Carolina Power & Light Company

OG-137  
Ref: OG-110,  
12/1/83 &  
OG-117  
3/9/84  
October 25, 1984

Westinghouse Owners Group  
Program to Address Generic Letter 83-10 - RCP Trip  
Response to NRC Questions

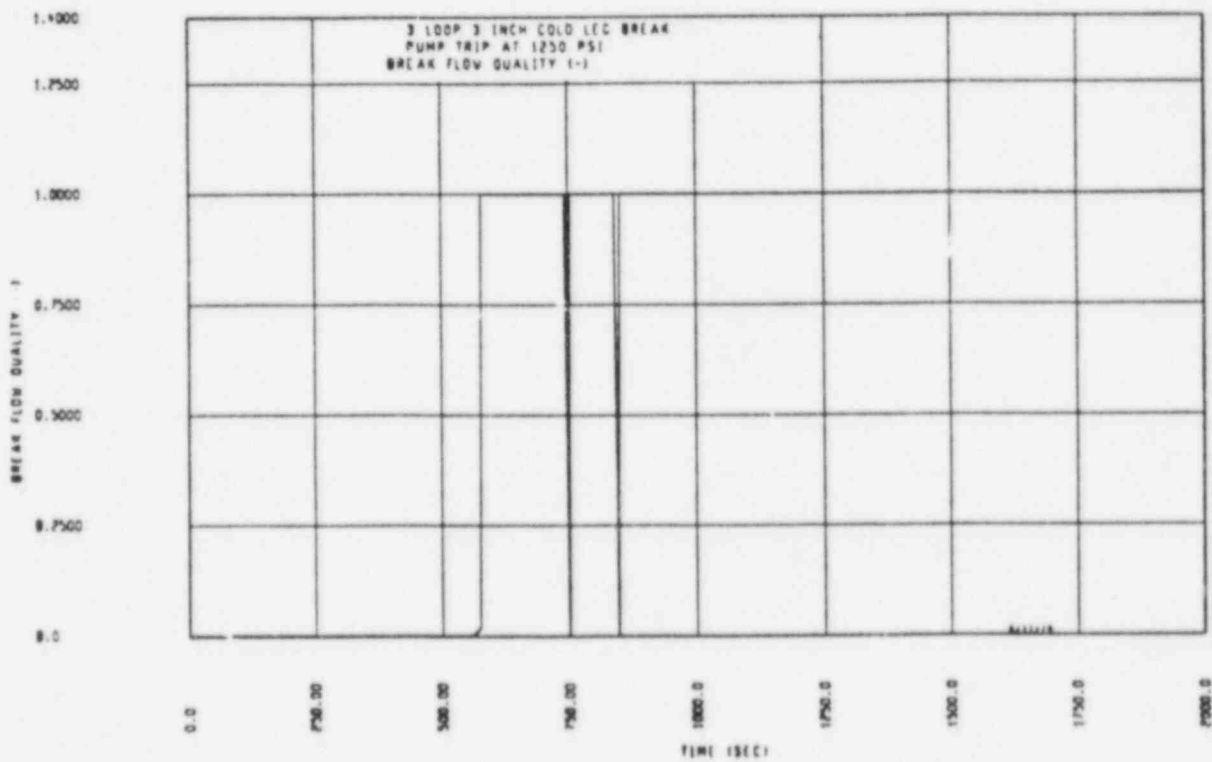
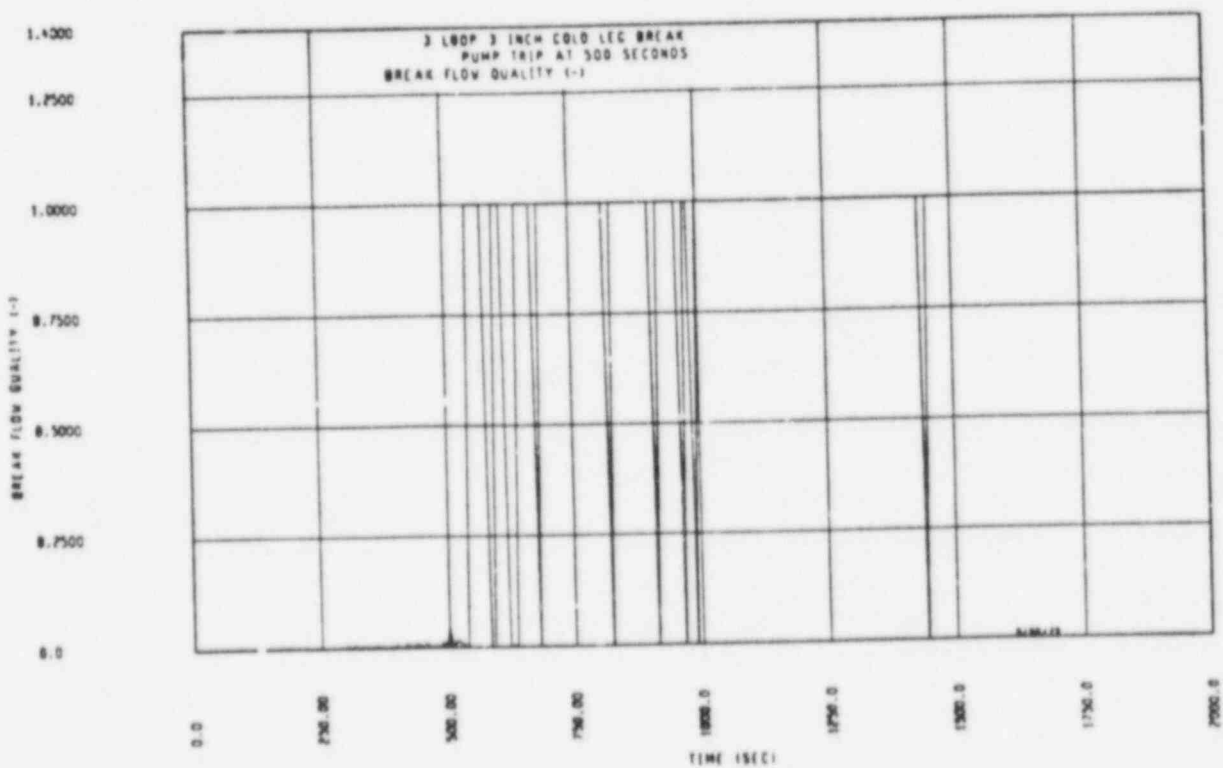
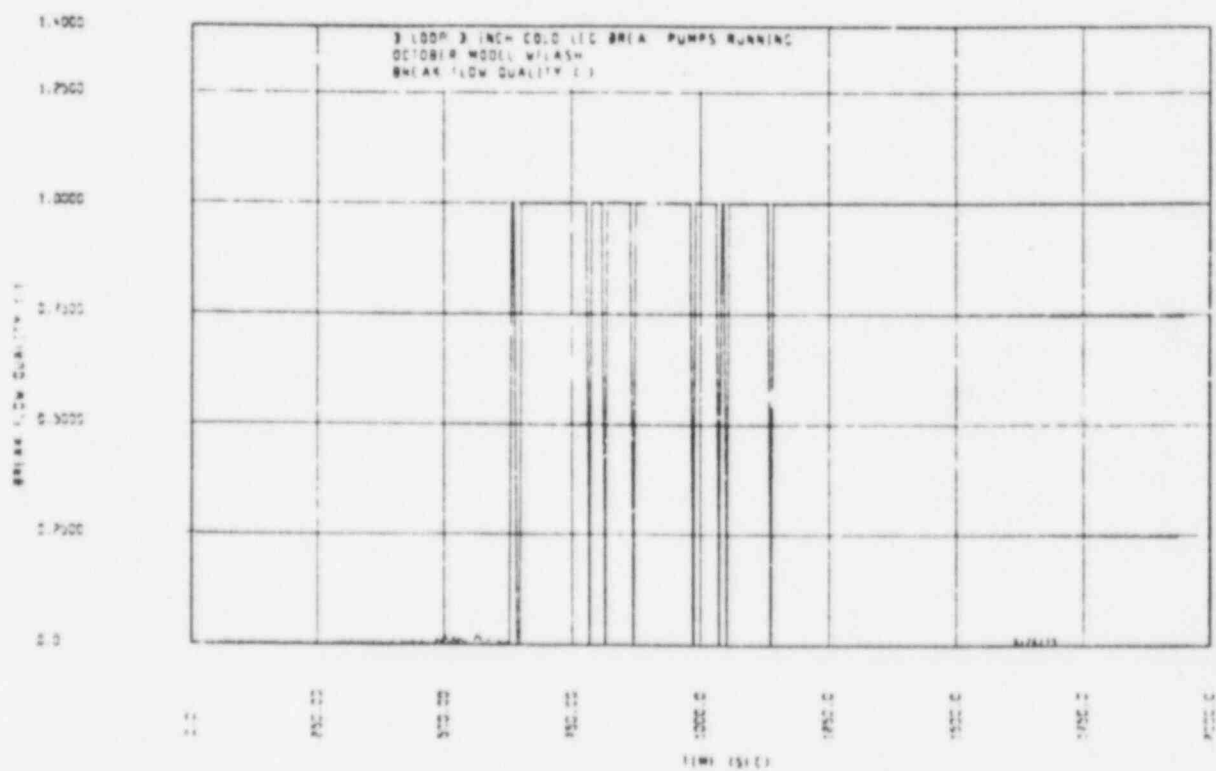
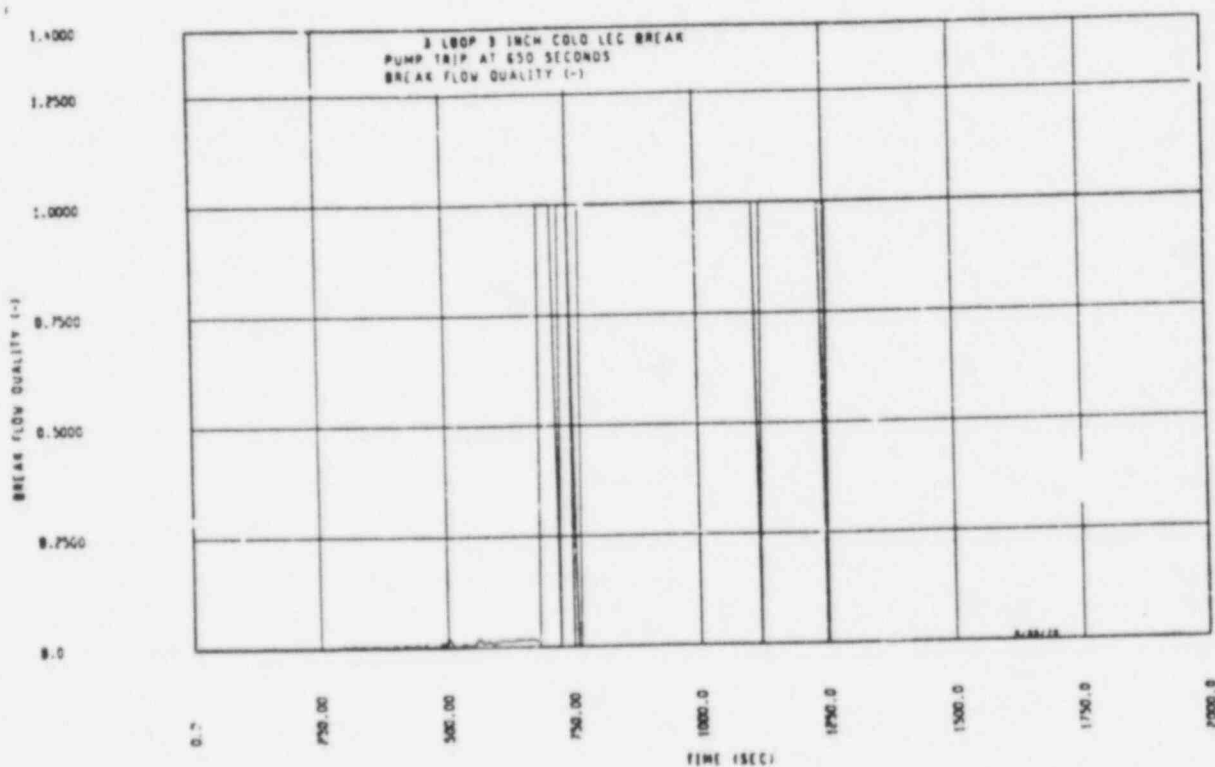
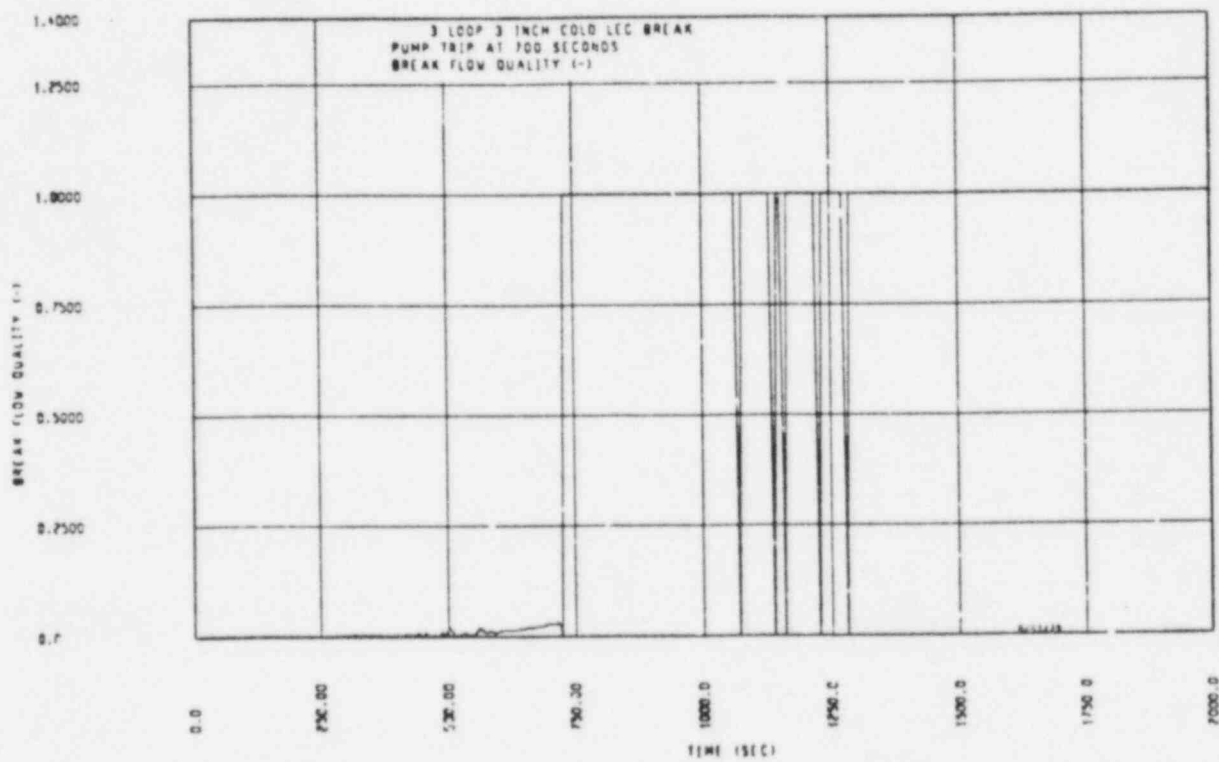
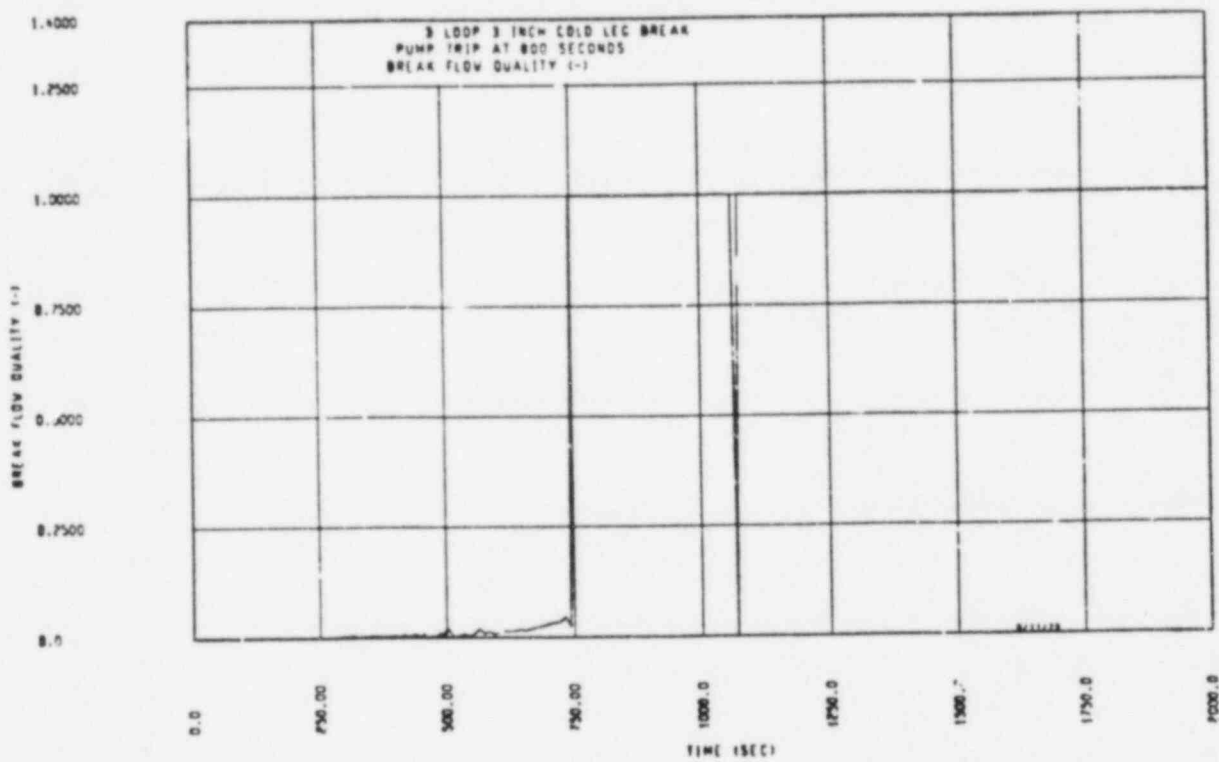
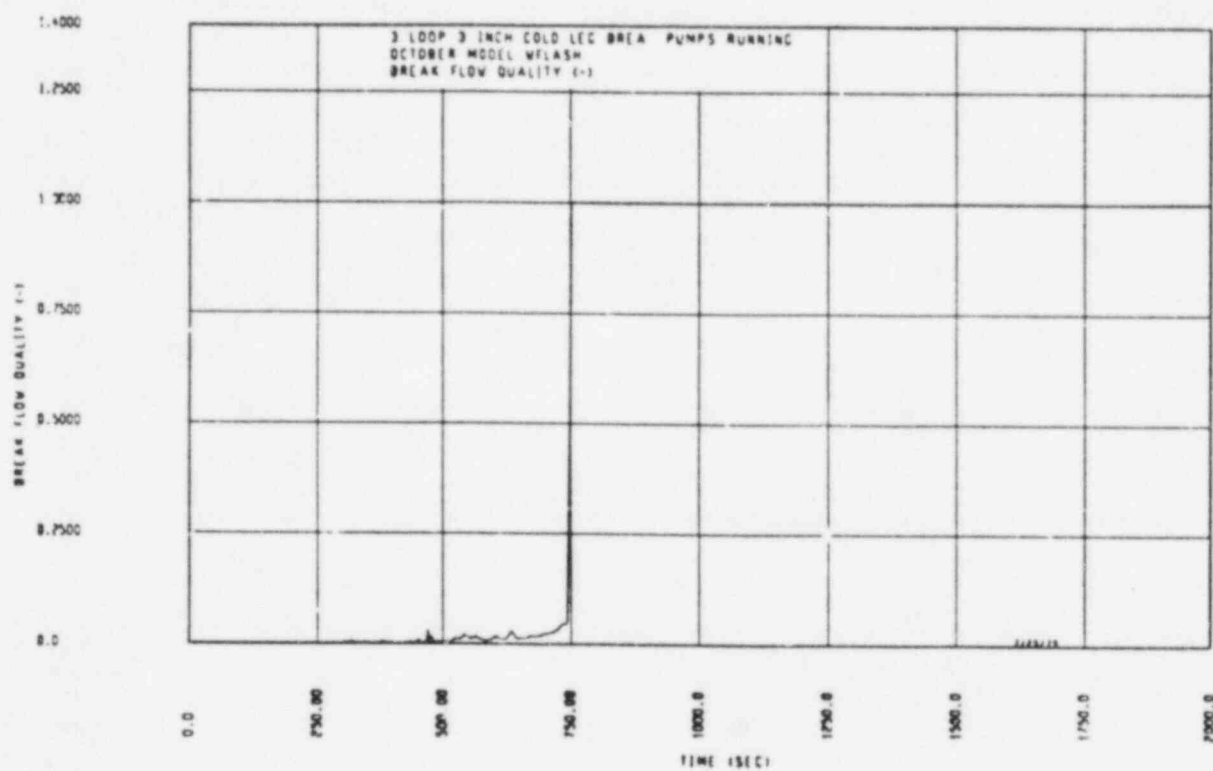
Q.10 Provide a plot of the quality or void fraction in the cold leg near the break as a function of time for the cases presented in Figure 1 on page 18 of Reference 1.

A.10 See the attached figures.
